XOMOX

May 3, 1993

IMPORTANT SAFETY NOTICE PLEASE READ CAREFULLY

Subject: Cover bolt fracture on Xomox Tufline Plug Valves at New Hampshire Yankee Seabrook Station. Xomox Tufline sleeved plug valve models 066, 067, 0366, 0367, 036, 037, 0336, 0337, 046, 047, 056, 057, 166, 1366, 136, 1336, 027, 0327, 126, 1326, 1626 with SA/A 193 Grade B6 cover bolts are the subject of this notice.

TYPICAL XOMOX TUFLINE SLEEVE PLUG VALVE SHOWING LOCATION OF COVER BOLTS

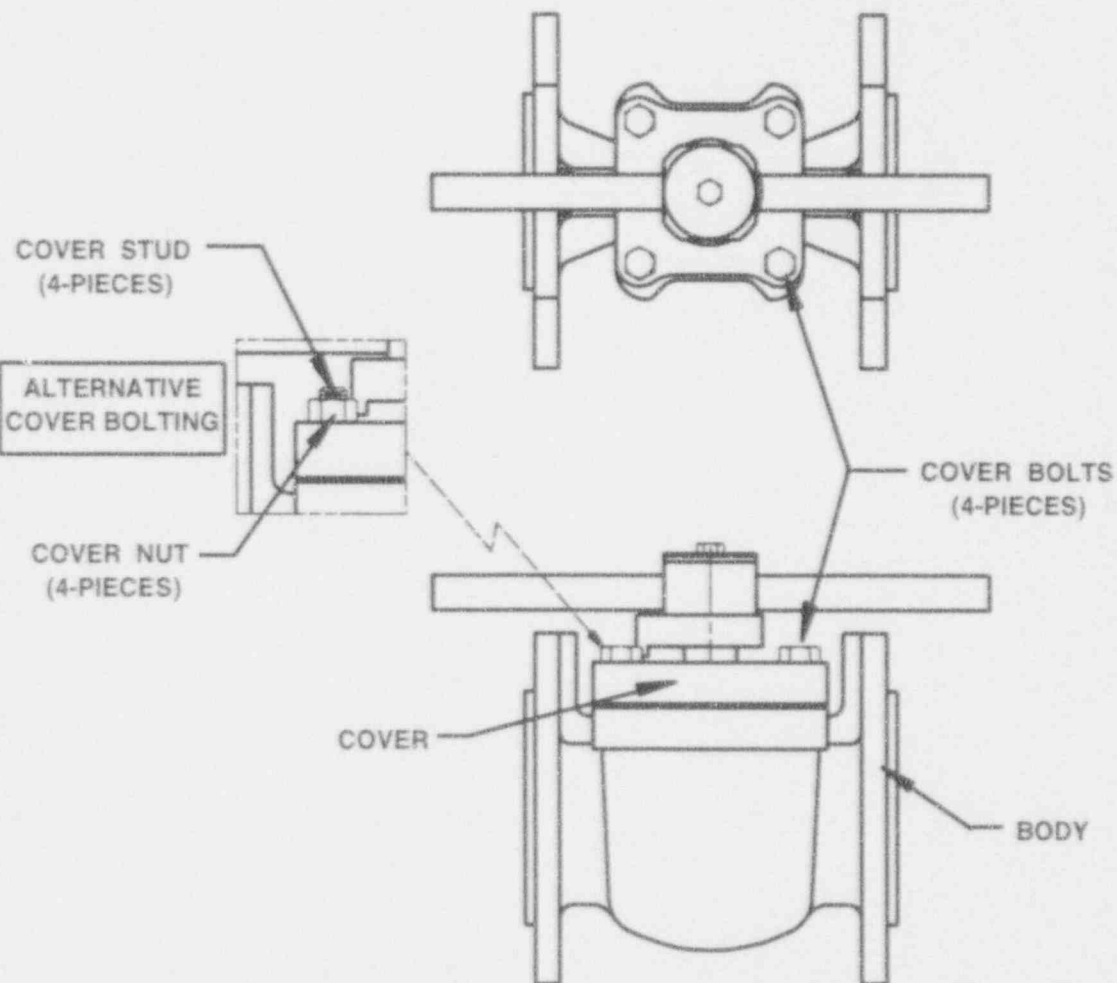
Purpose: Xomox is issuing this information notice to alert addressees to problems with SA/A 193 Grade B6 cover bolts on Xomox Tufline plug valves experienced at New Hampshire Yankee-Seabrook Station. It is expected that recipients will review this information for applicability to their facilities and consider actions, as appropriate, to avoid similar problems. *See attached diagram of valve for bolt location.*

Problem: In July of 1992 a Xomox Tufline plug valve, supplied in 1981 to New Hampshire Yankee-Seabrook Station, was discovered with 3 of the required 4 cover bolts fractured. Further inspection revealed 2 additional valves, also supplied in 1981, with 2 of the 4 bolts fractured. The cover bolt material, SA/A 193 Grade B6, was supplied in accordance with the design specification for these valves. The SA/A 193 material specification for Grade B6 does not call out maximum hardness and the bolts which fractured had hardness levels averaging 37 Rc. New Hampshire Yankee determined the cause of the fracture to be Intergranular Stress Corrosion Cracking (SCC). New Hampshire Yankee previously communicated this incident through the INPO Nuclear Network System operating experience report OE 5817.

Action: New Hampshire Yankee-Seabrook replaced certain installed SA/A 193 Grade B6 cover bolts with SA 564 Type 630 condition H1150 material. Recipients of this notice should conduct their own study and reach their own conclusion regarding appropriate actions to avoid similar problems.
